**Notification# # 20240826012.0
Marking Standardization for Select Devices
Information Only**

Date: August 28, 2024
To: Newark/Farnell PCN

Notification Number:		20240826012.0		Notification Date:		August 28, 2024	
Title:		Marking Standardization for Select Devices					
Customer Contact:		Change Management team		Dept:		Quality Services	
Change Type:							
☐	Assembly Site	☐	Design	☐	Wafer Bump Material	☐	
☐	Assembly Process	☐	Data Sheet	☐	Wafer Bump Process	☐	
☐	Assembly Materials	☐	Part number change	☐	Wafer Fab Site	☐	
☐	Mechanical Specification	☐	Test Site	☐	Wafer Fab Materials	☐	
☒	Packing/Shipping/Labeling	☐	Test Process	☐	Wafer Fab Process	☐	
Notification Details							
Description of Change:							
This notice is to communicate an update in the device symbolization format for the devices in the product affected selection as follows:							
		Current		New

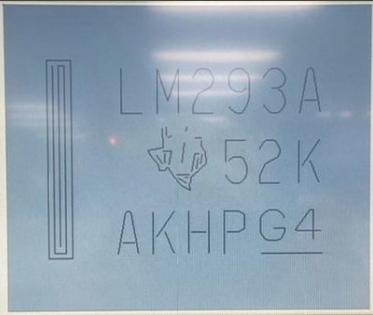
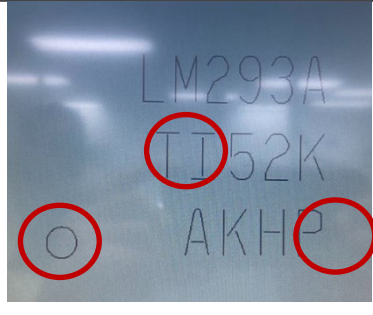
**ECAT	Include Value		Remove			
	Pin One Designator	Bar		Dot			
	TI Bug	Include		Replace with "TI" text			
Example							
** - Not all devices have ECAT information included in the symbolization, but for the ones that do, this information will be removed.							
Reason for Change:							
Marking Standardization							
Anticipated impact on Fit, Form, Function, Quality or Reliability (positive / negative):							
None							
Changes to product identification resulting from this notification:							
Device symbolization							
Product Affected:
